Radiation Surveillance Associates, Inc.  
1771 South 900 West, Suite #10  
Salt Lake City, Ut 84105

U.S. Nuclear Regulatory Commission  
Regulatory Issues Section  
Low Level Waste Management and Decommissioning

Re: MolyCorp, Washington, Pa. Facility and RSA Report,  
"A Subsurface Survey for Thorium Content,"  
Dated December 27, 1990.

Justification of the Calibration Factor used for Borehole Measurements of  
Underground Radiation Exposure Rates and Average  $^{232}\text{Th}$  Concentration  
and  
Response to NRC Comments Dated October 29, 1992.

Figure 5: Underground Background Gamma Radiation

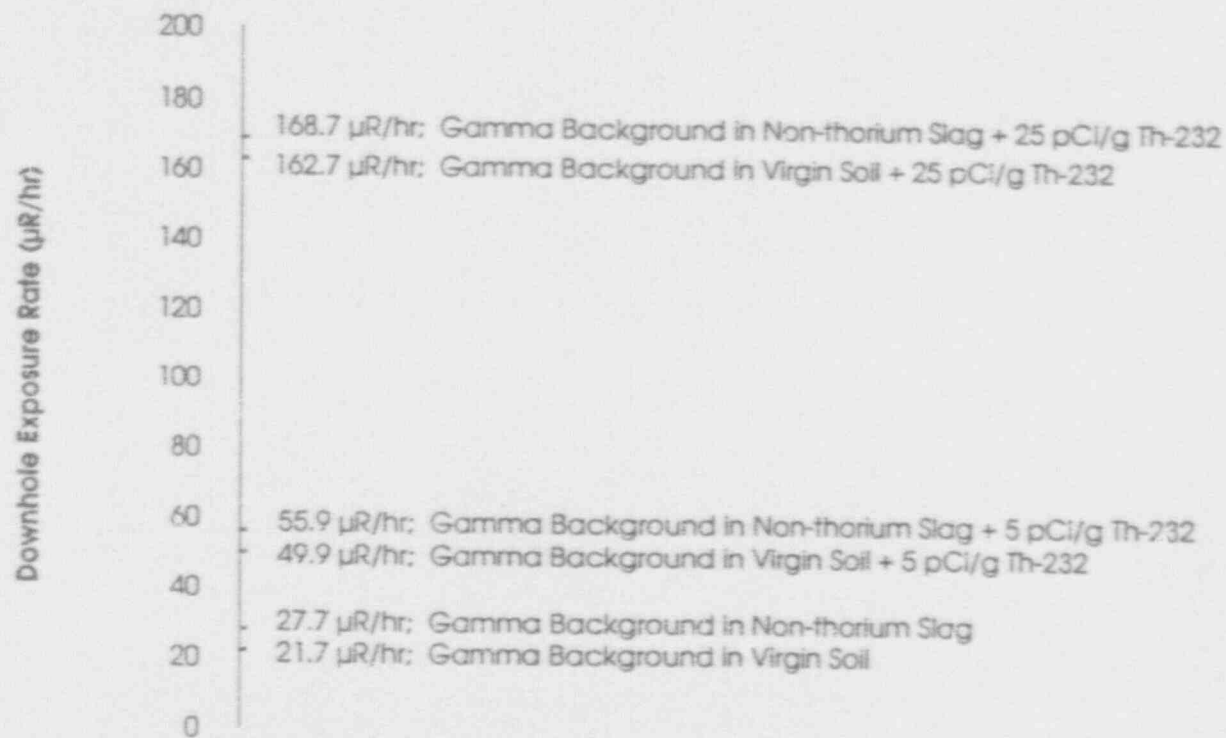
2. The background count rate underground established in virgin soil was 1726 cpm and is discussed in detail in the preceding report. The 2000 cpm figure plotted in the RSA 1990 Report was a rounded number used for the purposes of the RSA 1990 Report. We agree that the results in borehole #28 do not represent

background was rounded to the first significant figure in that report (i.e., 2000 vs. 1726 cpm in virgin soil). However in this and subsequent reports we will not round off background measurements to less than three significant figures. In this report all logging results will be presented in exposure rate in  $\mu\text{R/hr}$  which is the primary calibrated measurement.

Figure 10  
Radiochemical Analysis of Th-232 Concentration in Core Samples from BH#29 and BH#32 vs Downhole Measurements of Gamma Exposure Rate; and, Average Th-232 Concentration in Soil Calibrated against Downhole Exposure Rate.

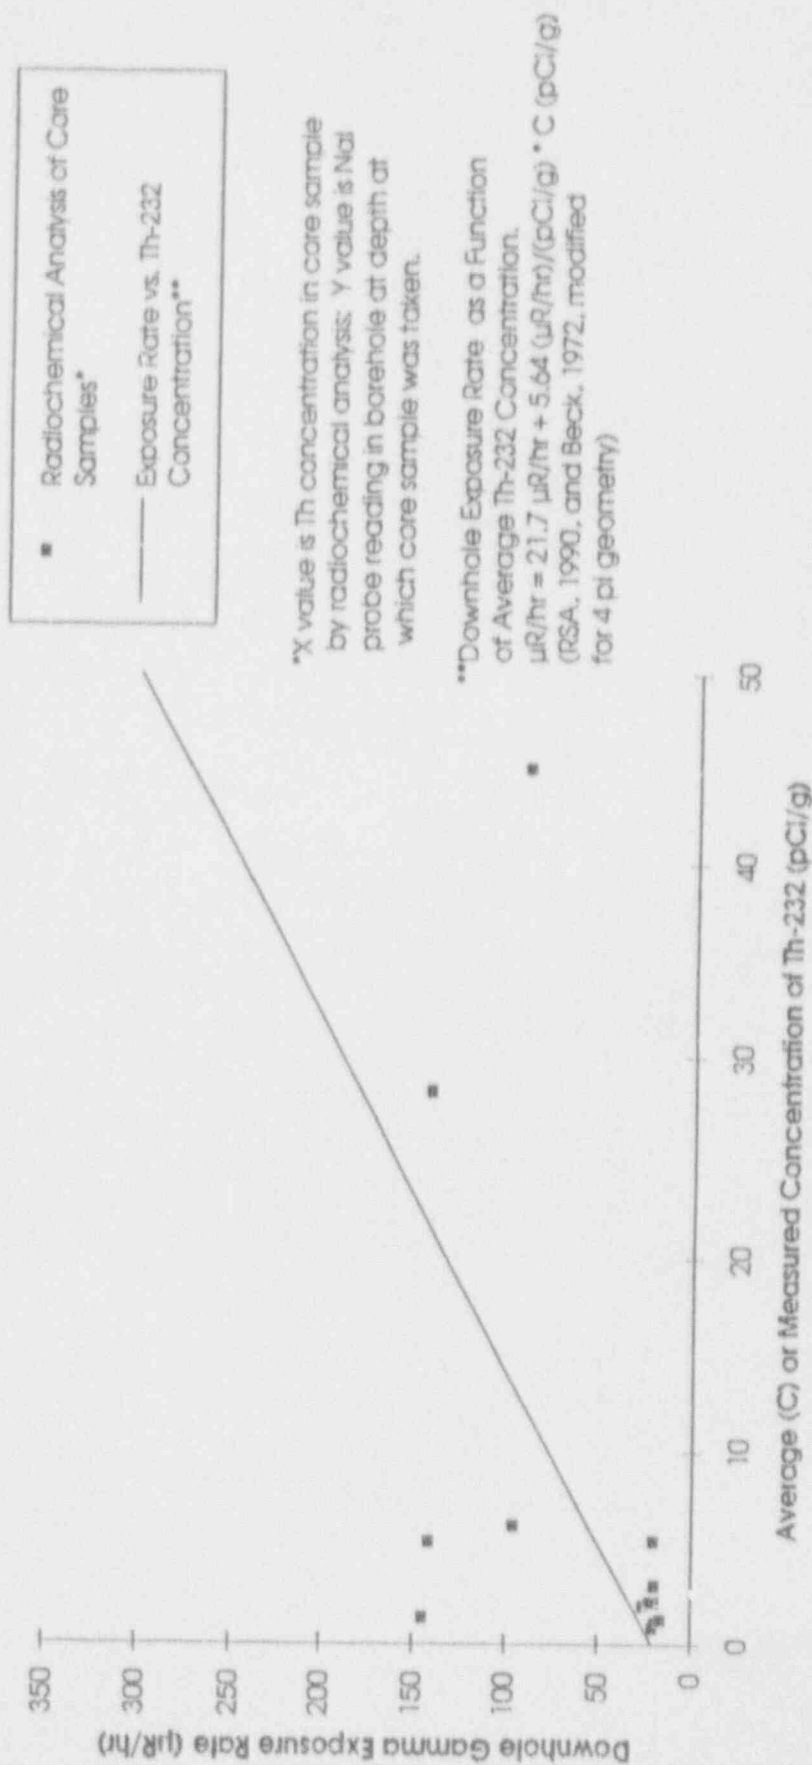
9. A reply to these comments will be made by MolyCorp staff. However we believe that a number of pilot studies such as those suggested by the NRC will be both useful and essential to effectively plan for decontaminating the site. In its review of the report the NRC staff indicated that it was not convinced that the

Figure 10 is a scatter plot of exposure rate ( $\mu\text{R/hr}$ ) measured downhole (at the depth where the soil sample was taken) as a function of  $^{232}\text{Th}$  concentration (pCi/g, measured by alpha spectrometry) of the soil sample. The line on the graph in Figure 10 is the calibration curve for the NaI probe (expressed in  $\mu\text{R} \cdot \text{hr}^{-1}/\text{pCi} \cdot \text{g}^{-1}$ ) derived from the work by Beck and reported in the RSA 1990 report. Several of the points show less thorium than the response curve would predict and several show more. The variation is, in fact, quite large, but not surprising given the fact that the soil volume sampled was very small compared to the volume of the region sampled by the NaI gamma probe.

The advantage of the **down hole gamma measurements** is that they **integrate the results over a larger volume of soil** than a single soil sample; the **results are also directly interpretable in terms of ability to produce external exposure**. Therefore RSA sees no reason to believe that the calibration factors

developed in the RSA 1990 Report are not valid. However one needs to understand that they represent averages over much larger volumes of soil than would be taken in any reasonable size single soil or sediment sample. Even the volumes over which the downhole external gamma measurements integrate, are small compared to the volumes of material which would contribute significantly to any future exposures.
